REMARKS

In the non-final Office Action mailed May 01, 2007, claims 1-16 remain pending in this application. Claims 1-8, 13, 14 and 16 stand rejected. Claims 9-12 and 15 have been objected to. With this Amendment, claims 1, 3-7, 9, 13 and 15 have been amended. No new matter has been added. Reconsideration of the present application in view of the amendments and remarks that follow is respectfully submitted.

AMENDED SHEET – FIG. 4

FIG. 4

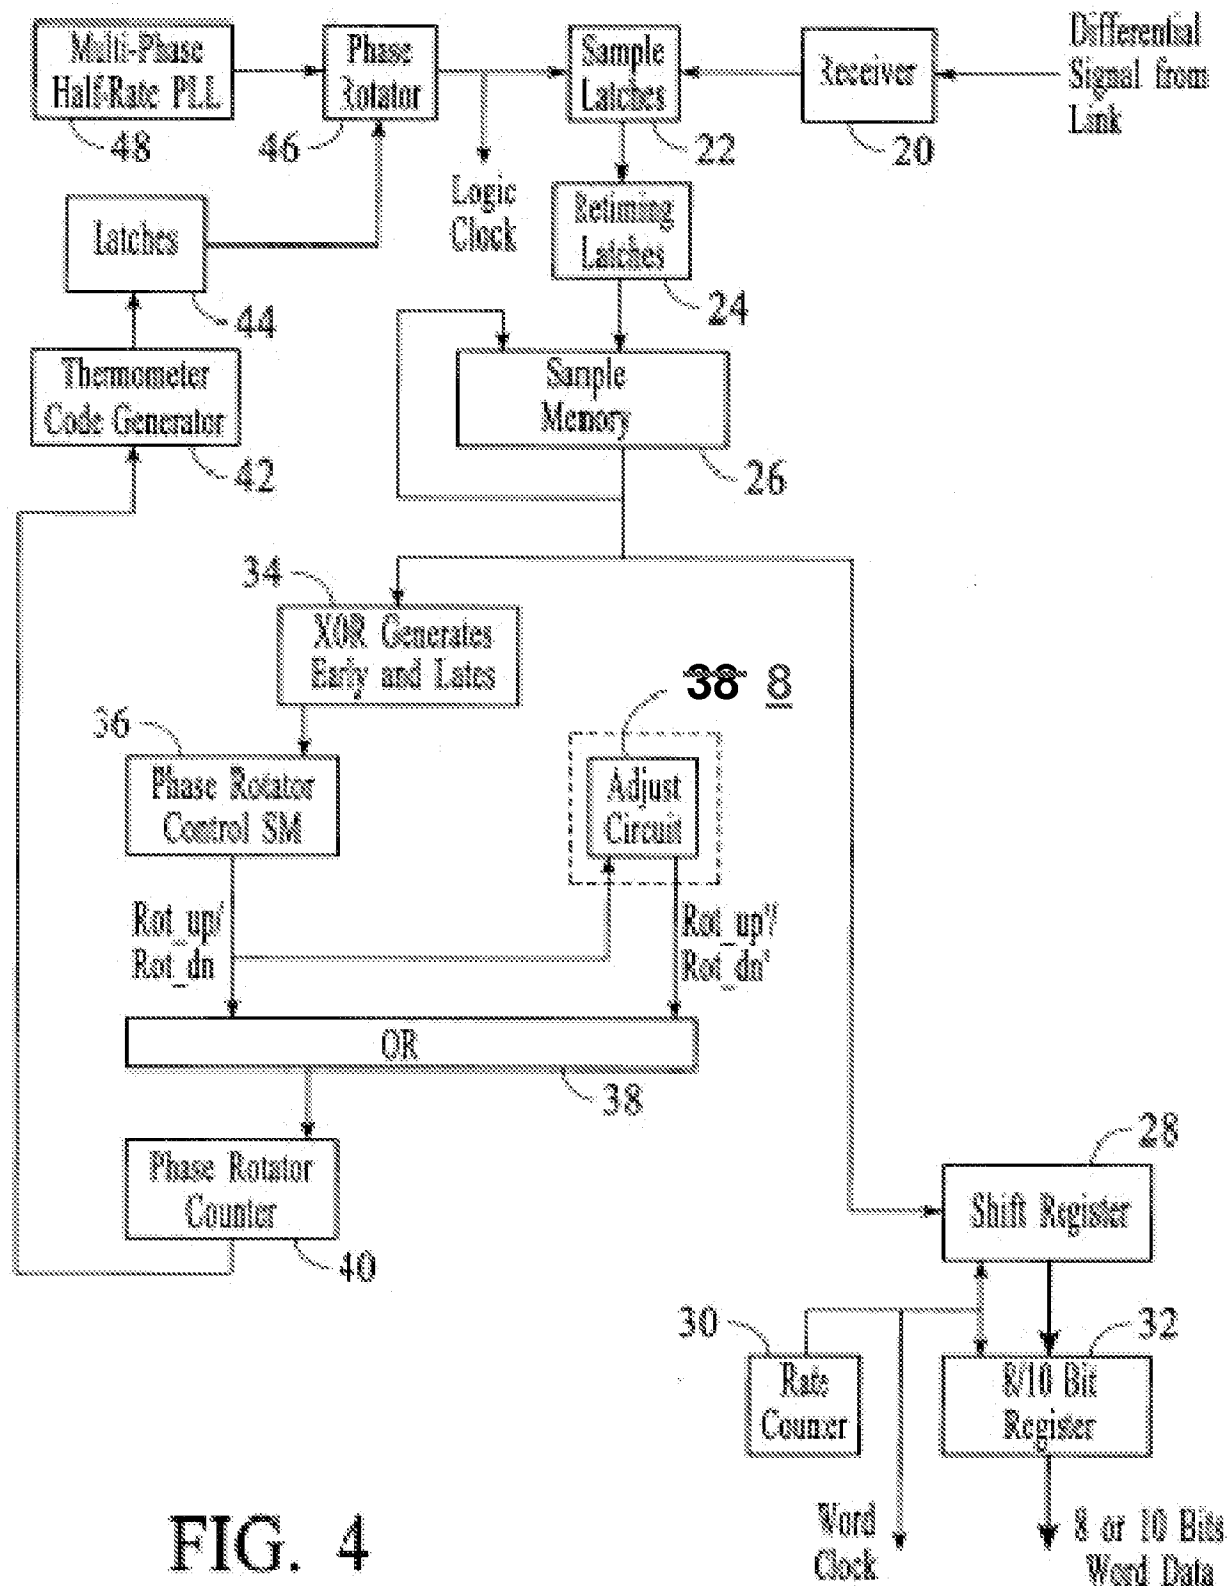
Figure 4 has been objected to by Examiner due to a 'reference number "38" being used to designate both an "OR" block and an "adjust circuit"' in the referenced figure. Applicant has corrected Examiner's cited objection and has included as a part of this Amendment a Replacement Sheet for Figure 4 where Applicant has maintained the use of reference number 38 for the "OR" block and has corrected the reference number for the "adjust circuit" to be "8," which is correctly referenced in the Specification.
